69388 - Radcliffe Market Chambers.

Non-material Amendment Briefing Document

P5860_1200 rev P12 Proposed Level B1 - NMA Submission - February 2024.

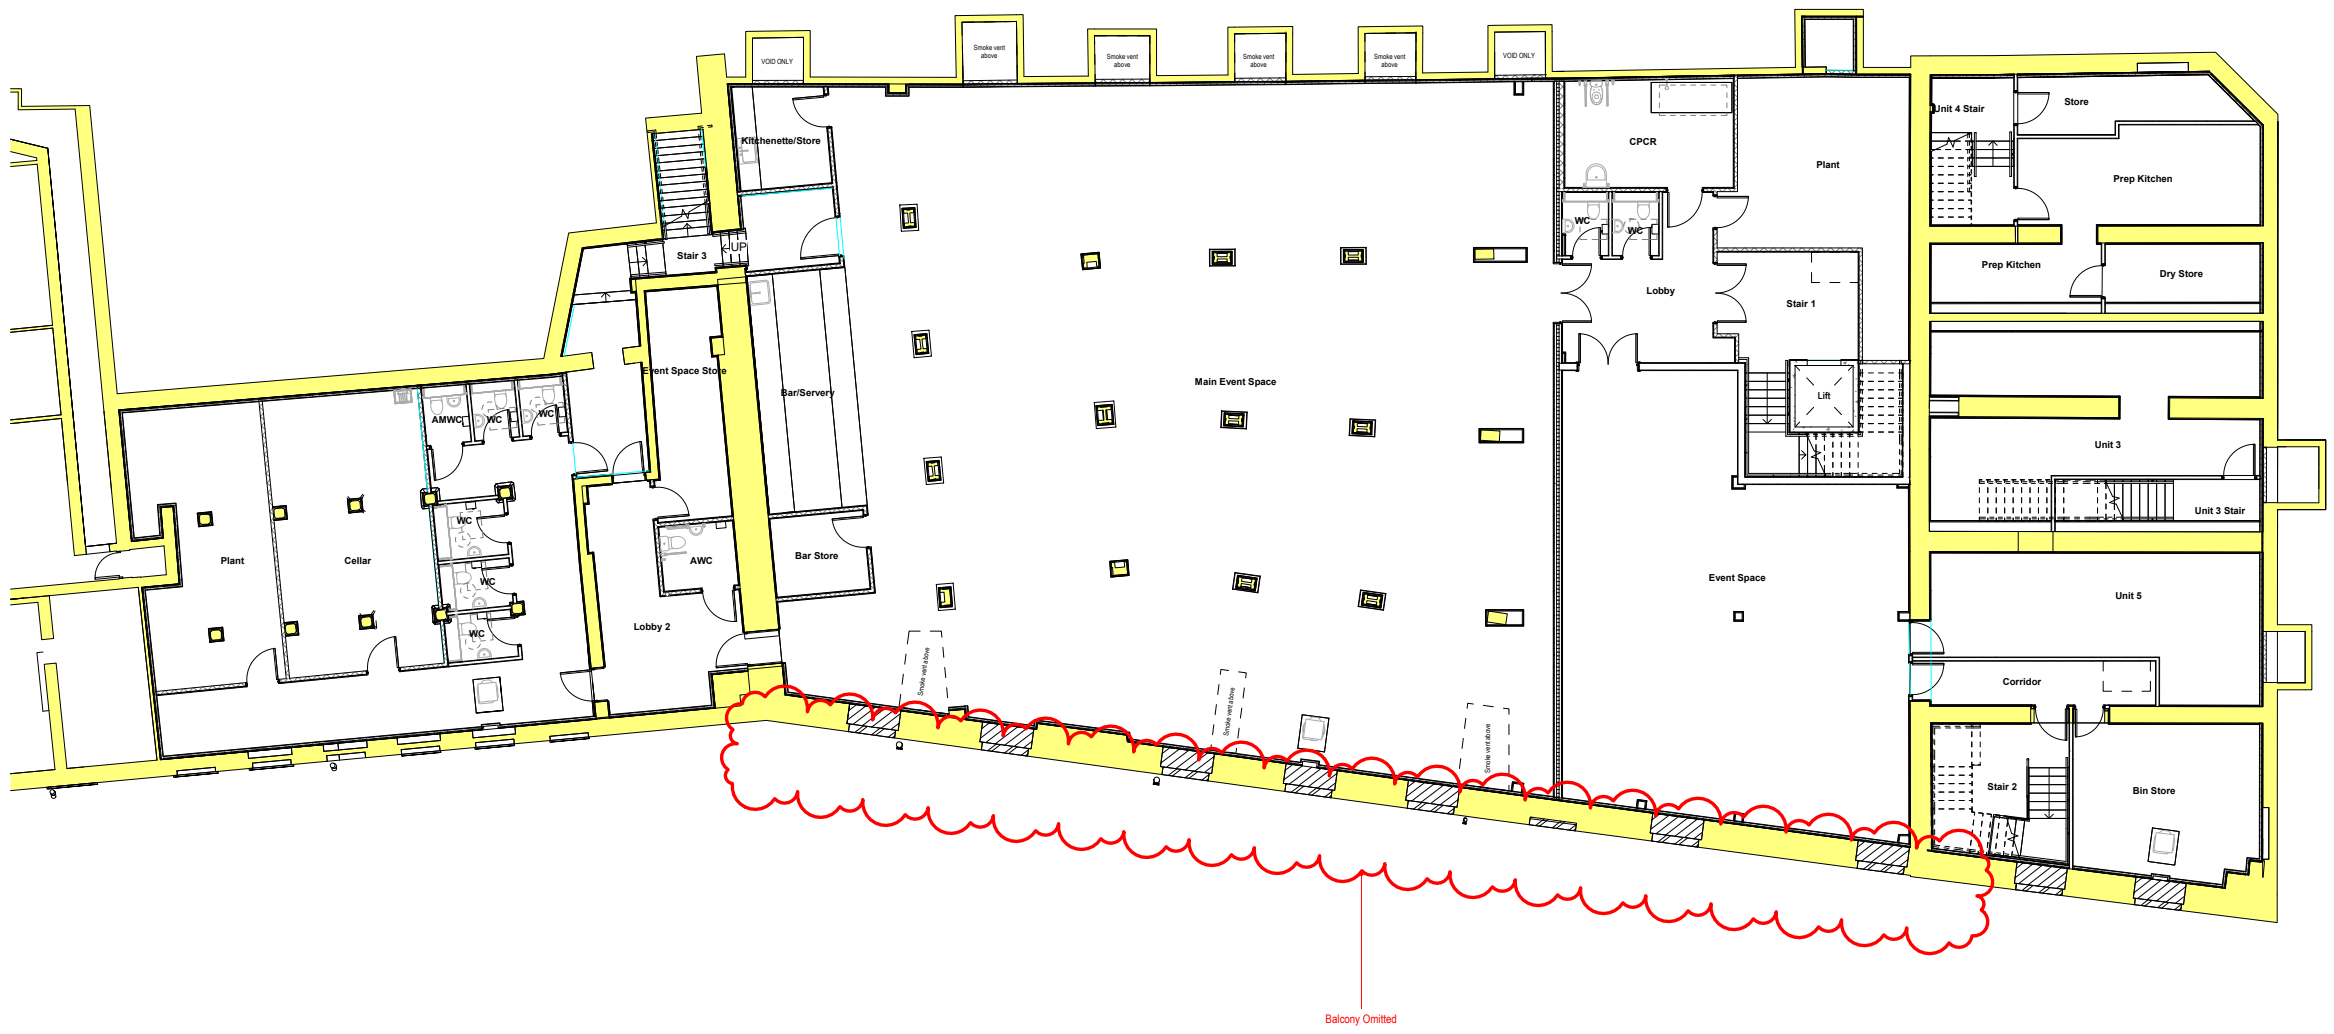
Balcony Omitted.

P12	Non-Material Amendment - Balcony Omitted.	MBR	09.02.24
P11	Issued for Planning.	DY	23.02.23
P10	Columns omitted and grid lines added.	DY	07.02.23
P09	Stage 3 issue	AT	14.10.22
P08	General Layout Updates	AT	09.09.22
P07	Sanitaryware indicated.	DAS	17.08.22
P06	General updates to comments	LM	12.08.22
P05	Updated - new sections added	LM	29.07.22
P04	Updated to suit fire strategy. Stair 1 width reduced. Sliding door to minor event space changed to side hung. New door width between main event space and WCs widened.	DAS	23.06.22
P03	Stair 3 lobby width increased. Stair 1 lobby layout revised.	SS	09.06.22
P02	Smoke vents redistributed.	DAS	16.02.22
P01	Additional WCs and bar/servery shown.	DAS	15.02.22

P5860_1201 rev P14 Proposed Level 00 - NMA Submission - February 2024.

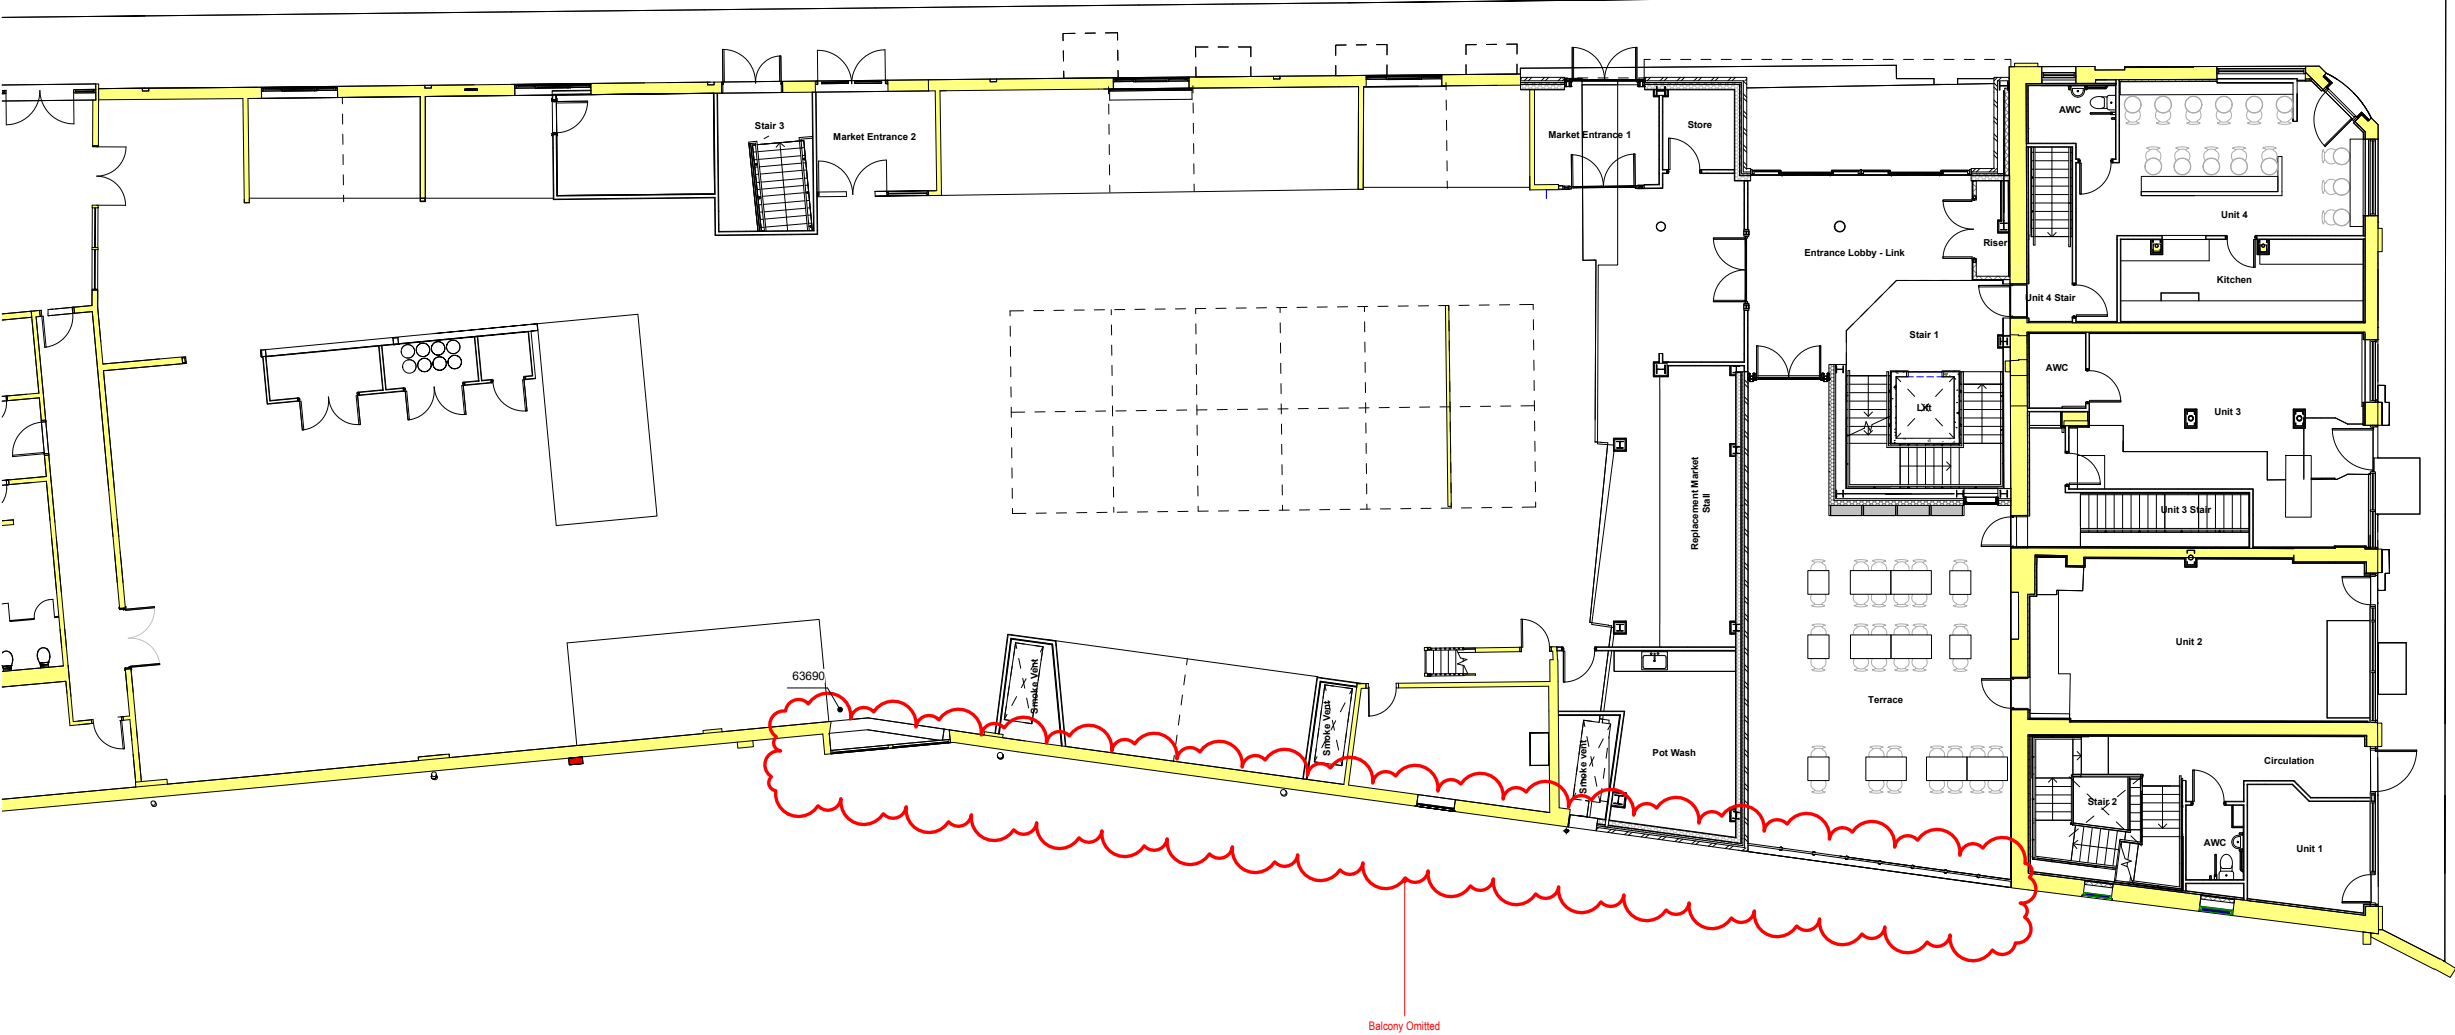
Balcony Omitted.

P14	Non-Material Amendment - Balcony omitted.	MBR	08.02.24
P13	Issued for Planning.	DY	23.02.23
P12	Possible furniture layout added to Balcony and Terrace areas.	DAS	16.01.23
P11	Updated to suit client comment. Balcony length reduced + alternative escape route and associated provisions to Market accommodation omitted.	DAS	10.01.23
P10	Stage 3 issue	AT	14.10.22
P09	General Layout Updates	AT	09.09.22
P08	Sanitaryware indicated.	DAS	17.08.22
P07	General updates to comments	LM	12.08.22
P06	Updated - new sections added	LM	29.07.22
P05	Updated to suit fire strategy. Final exit to stair 2 widened and lobby door omitted.	DAS	23.06.22
P04	Market Hall: External doors & lobby added. Link door swing handed.	SS	09.06.22
P03	Updated following client comment. Unit 3 and 4 updated. Oniel window and temp cellar added to Market Hall.	DAS	29.04.22
P02	Smoke vents redistributed + Pot Wash repositioned + Market Stalls indicated.	DAS	16.02.22

P5860_1202 rev P08 Proposed Level 01/02 - NMA Submission - February 2024.

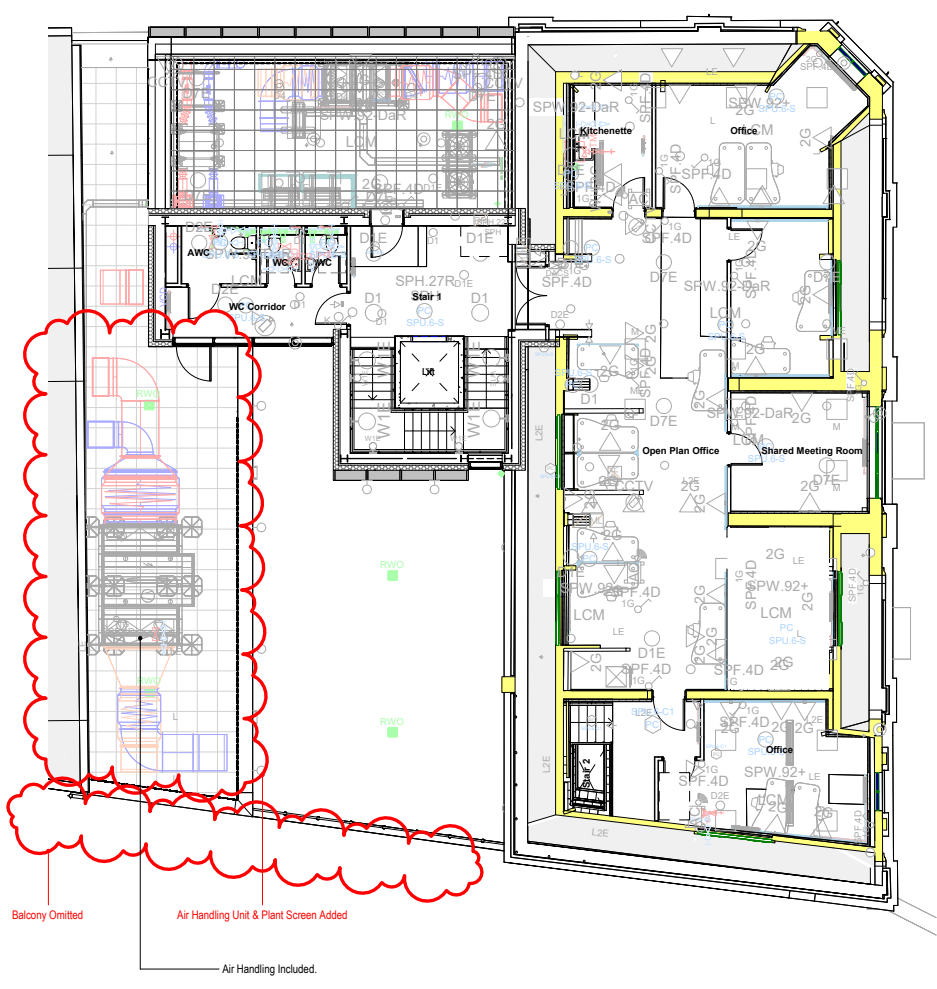
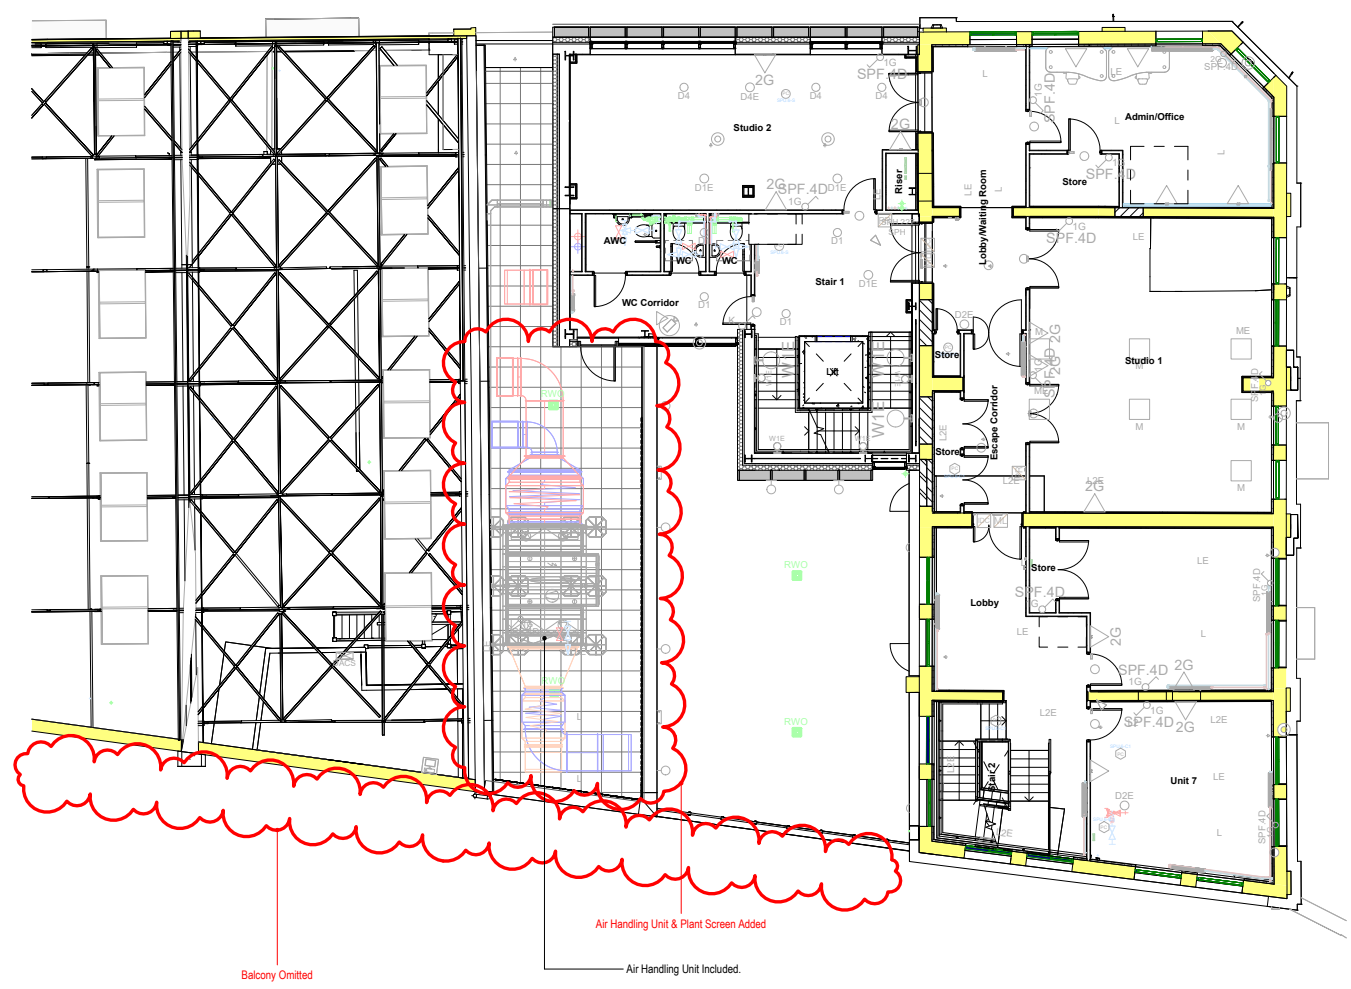
Balcony Omitted.
Plant Screen Added.

Rev	Description	By	Date
P08	Non-Material Amendment - Balcony omitted, Air Handling Unit added	MBR	09.02.24
P07	Issued for Planning	DY	23.02.23
P06	Updated to suit client comment. Balcony length reduced + alternative escape route and associated provisions to Market accommodation omitted.	DAS	10.01.23
P05	Stage 3 issue	AT	14.10.22
P04	General Layout Updates	AT	09.09.22
P03	General updates to comments	LM	12.08.22
P02	Updated - new sections added	LM	29.07.22
P01	Doors shown double swing	SS	09.06.22
Rev

P5860_1350 rev P08 Proposed Elevations - NMA Submission - February 2024.

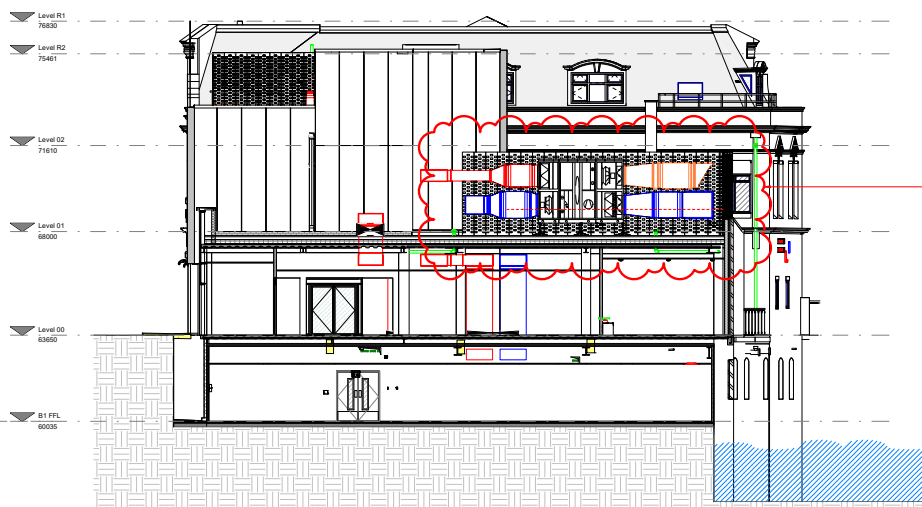
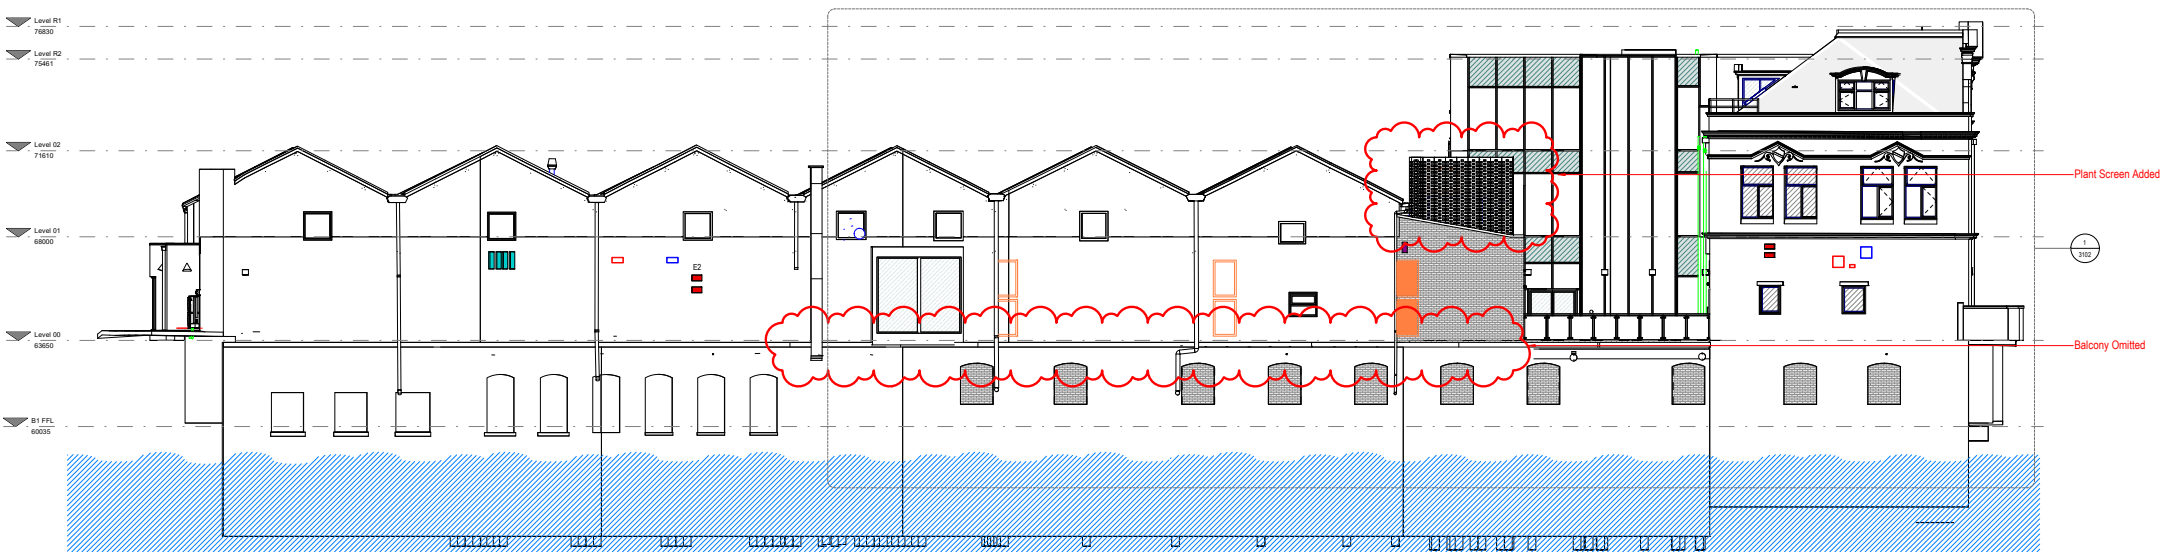
Balcony Omitted.
Plant Screen Added.

Rev	Description	By	Date
1	Initial Design	MBR	09.02.24
2	Non-Material Amendment - Balcony omitted, Bird boxes added, Drainage outlet pipes added to East elevation, Plant Screen Proposed	MBR	23.02.23
3	Window schedules & logs removed, material notes added and issued for planning	DY	07.02.23
4	Updated to suit client comment, material notes removed	AT	14.10.22
5	Stage 1 Issue	AT	09.09.22
6	Final Layout Updates	DAB	17.08.22
7	East Elevation updated following client comment	LM	12.08.22
8	General updates to comments	LM	24.08.22
9	Curtil wall and Window Schedules LM indicated		
10			
11			
12			
13			
14			
15			
16			
17			
18			
19			
20			
21			
22			
23			
24			
25			
26			
27			
28			
29			
30			
31			
32			
33			
34			
35			
36			
37			
38			
39			
40			
41			
42			
43			
44			
45			
46			
47			
48			
49			
50			
51			
52			
53			
54			
55			
56			
57			
58			
59			
60			
61			
62			
63			
64			
65			
66			
67			
68			
69			
70			
71			
72			
73			
74			
75			
76
